PROJECT TITLE: Zamora Disinfection Facility ZONE ATLAS/DRNG.FILE #:E-10

**RE: ZAMORA PUMP STATION AND RESERVOIR - Disinfection Facility - (E10-D8A).
GRADING AND DRAINAGE PLAN FOR BUILDING PERMIT APPROVAL.
ENGINEER'S STAMP DATED NOVEMBER 20, 1998.**

TITLE: ZAMORA WELL FIELD
DISINFECTION FACILITY
SITE GRADING AND DRAINAGE PLAN

SITE GRADING AND DRAINAGE PLAN
SCALE: 1"=20'

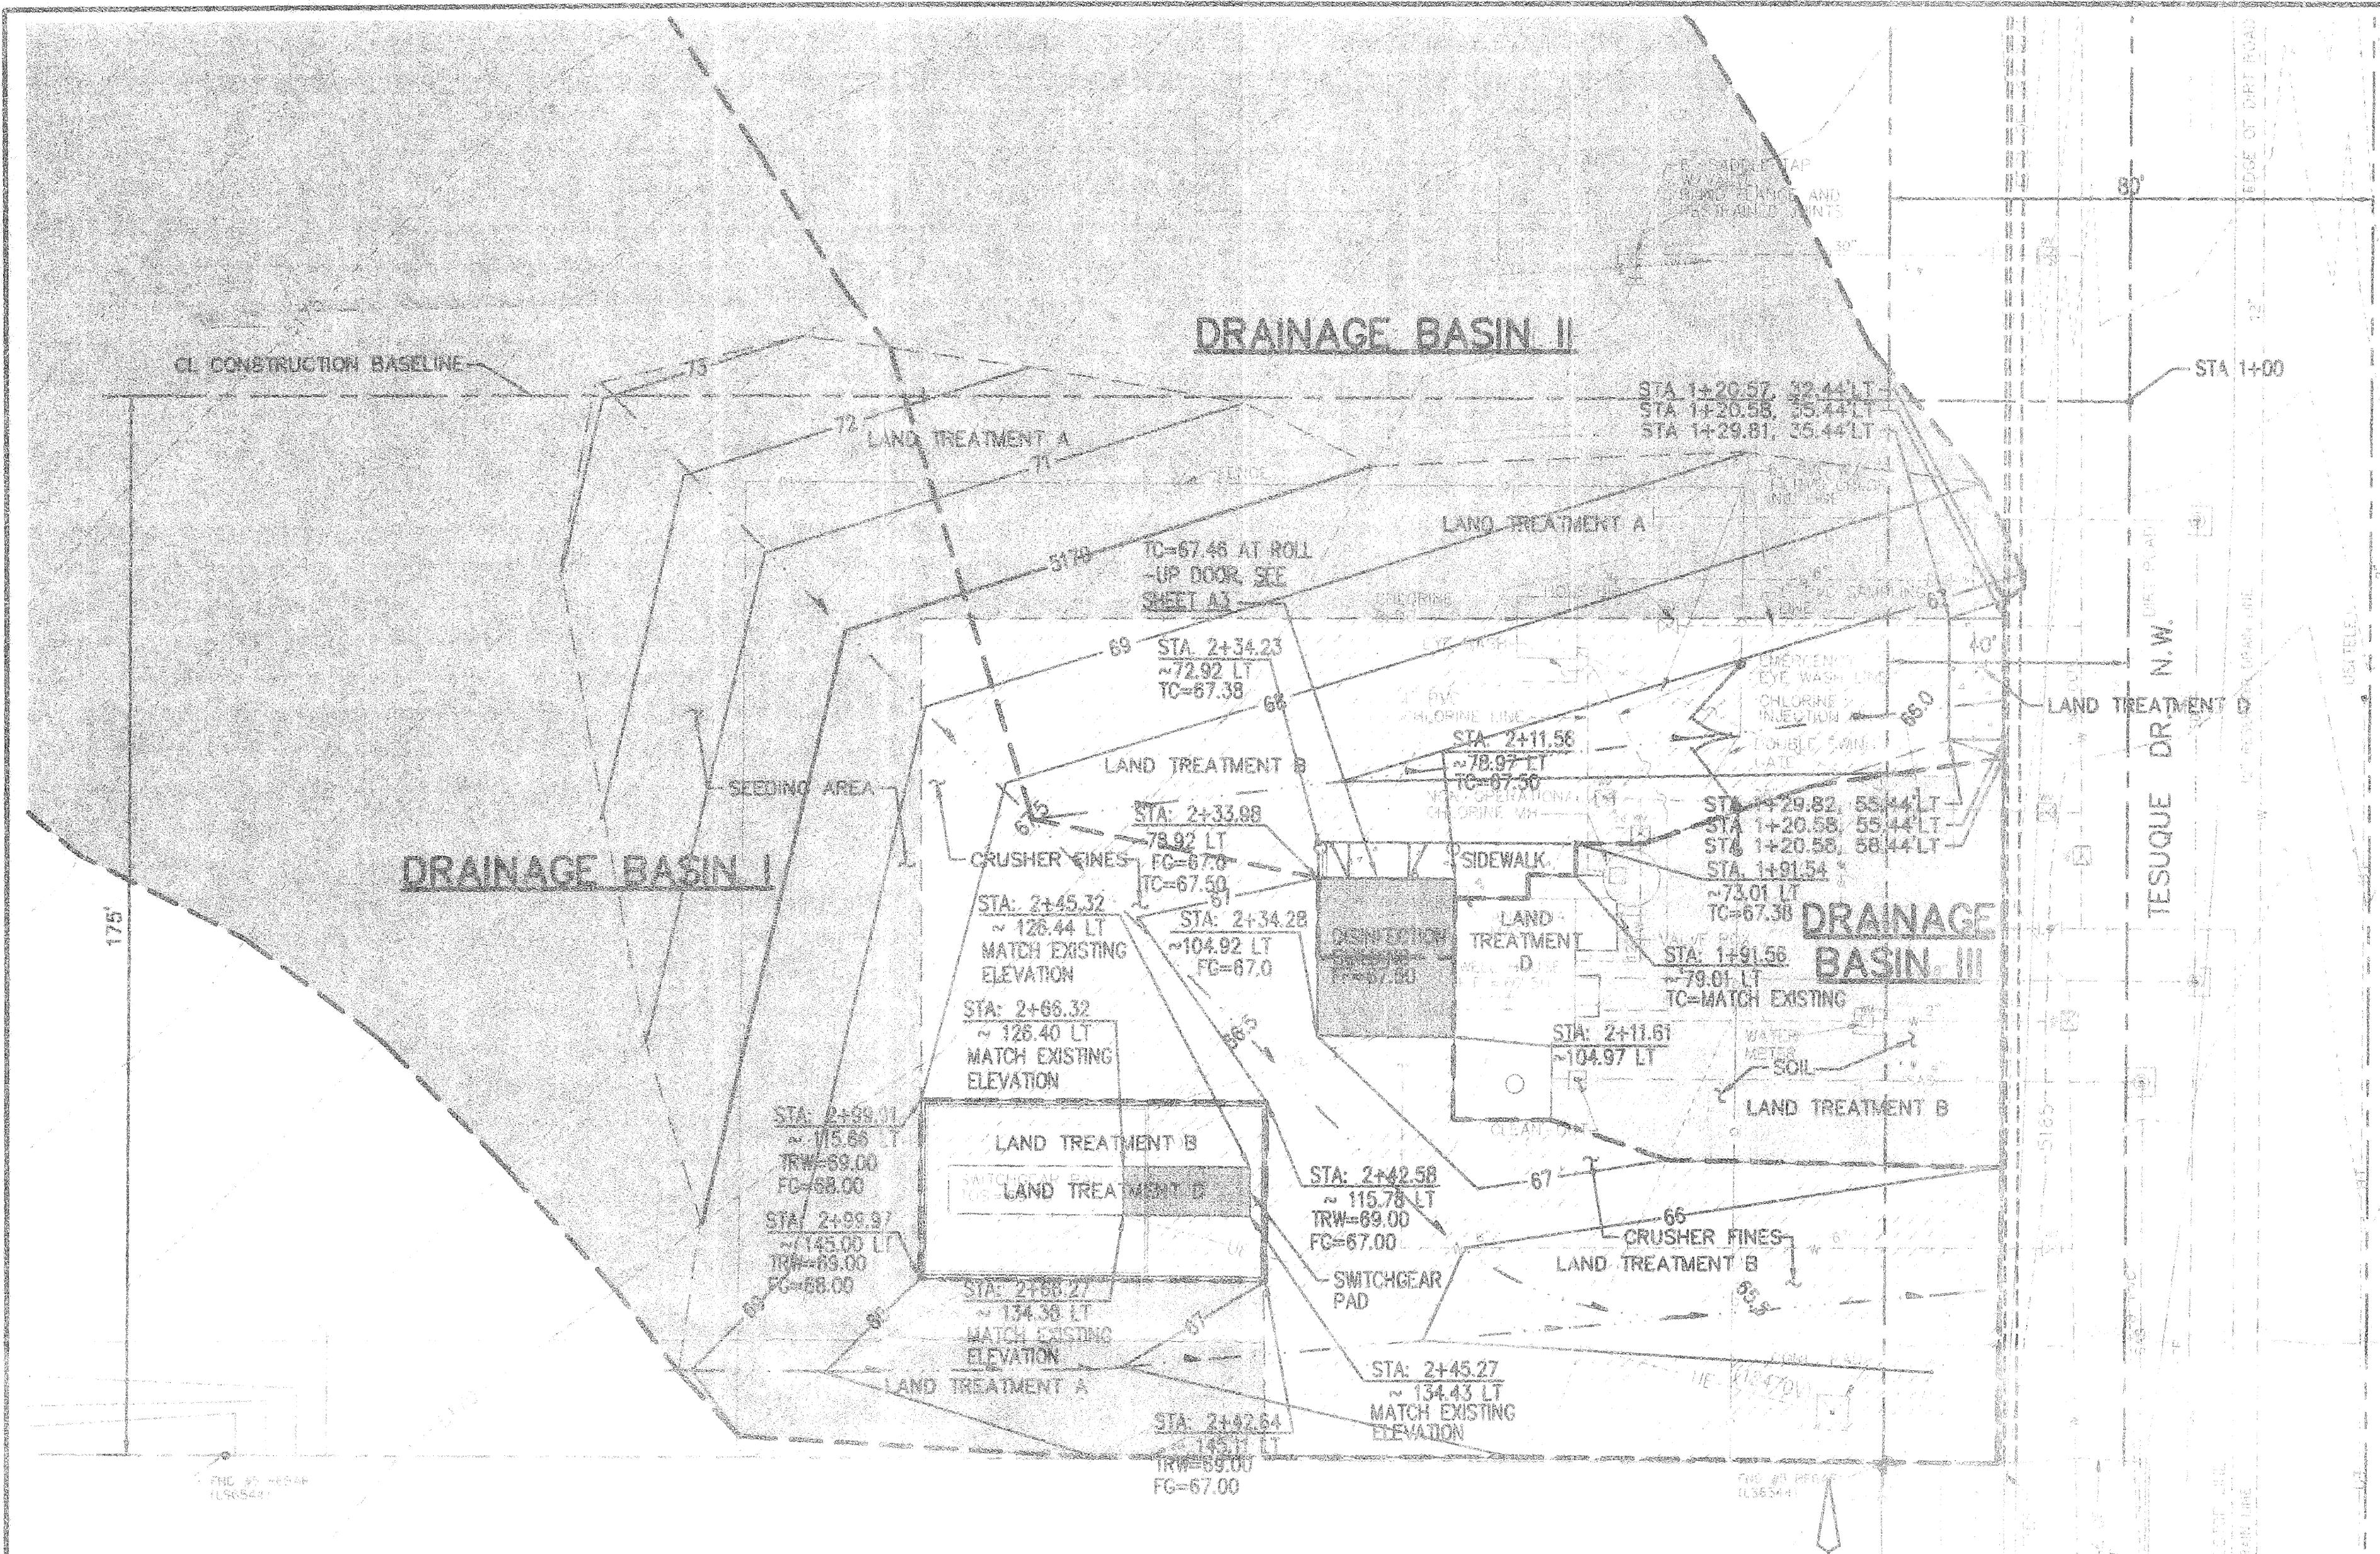
Based on the information provided on your November 23, 1998 submittal, the above referenced project is approved for Building Permit. The overall site plan, Engineer's Stamp dated August 27, 1997, for the pump station and reservoir had been submitted and approved with that submittal. Both are to be constructed at a future date.

Please attach a copy of this approved plan to the construction sets prior to sign-off by Hydrology.

Prior to Certificate of Occupancy approval, an Engineer's Certification per the DPM will be required.
